COMMUNICATION C234
ITEM NO. 4
COMMITTEE OF THE WHOLE
(PUBLIC MEETING)

Deposition for 8001 Bathurst Street

Official Plan Amendment File OP.19.016 Zoning By-law Amendment File Z.19.040

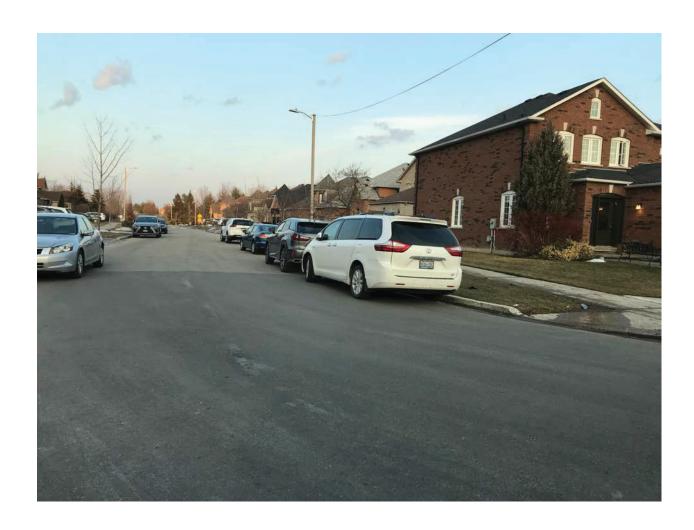
For those that don't know, the parking requirement for a Place of Worship, is calculated using 11 parking spaces per 100m2 of gfa. In that first submission, the City noted that the existing synagogue, with a gross floor space (GFA) of 5,326.4m2 required 586 spots, which it clearly did not, and does not have.

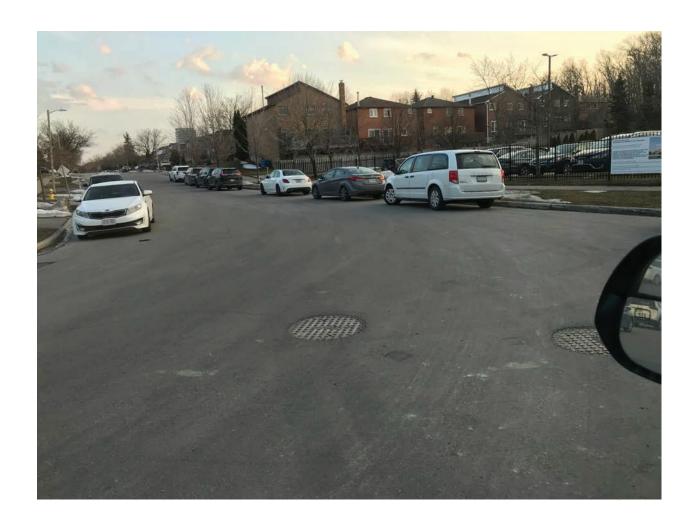
It's unclear to me why the applicant's most recent submission states that the existing structure is only 4,151m2, however, even that number requires 451 parking spots, still more than the development can accommodate. Please keep in mind, this does not account for the resident parking requirements.

(pictures below show snow covered parking spots, long after snow has begun to melt)

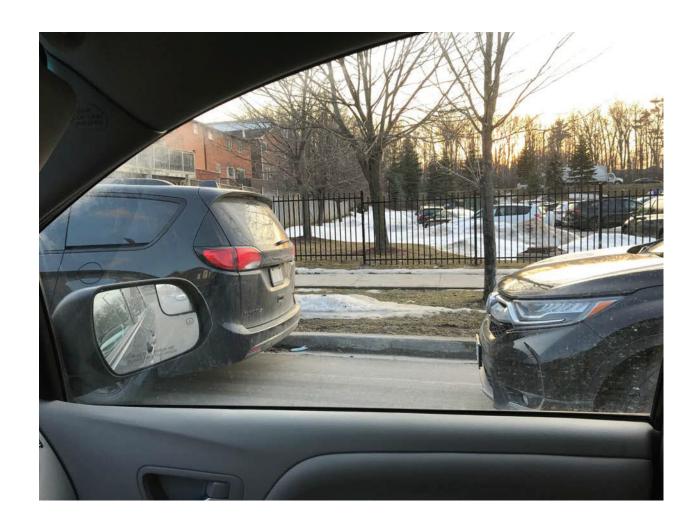
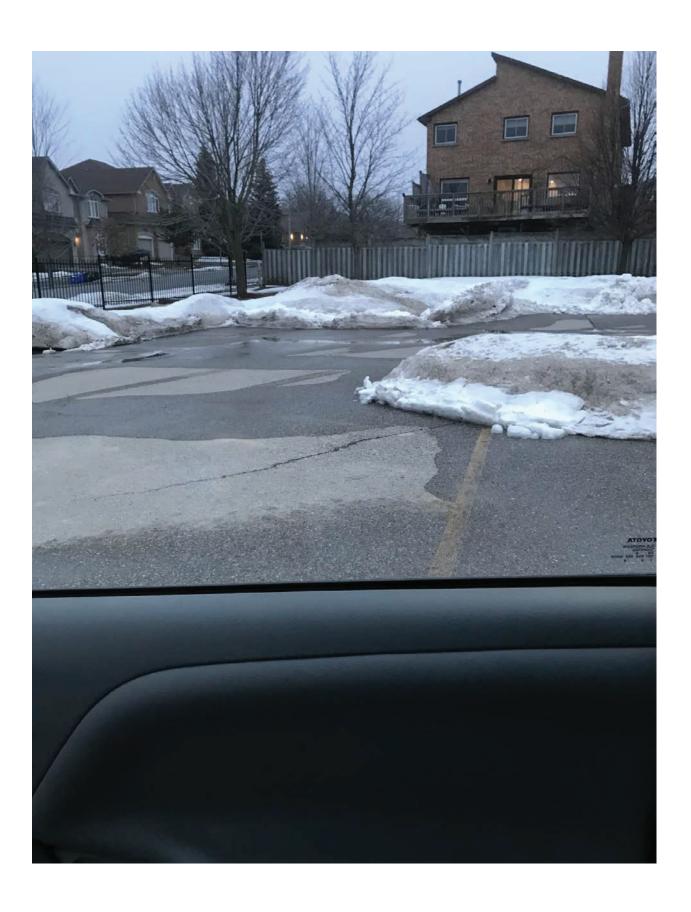
There are also other factors, besides parking lot closures that hinder the number of available parking spots. During this winter for instance, the snow mounds were significant and approximately 40+ parking spots were compromised, even after much had melted. The applicant has provided 91 and 86 sqm for snow storage at two corners of the site. That seems inadequate given the amount of snow we saw this year, which would easily spill over into parking space.
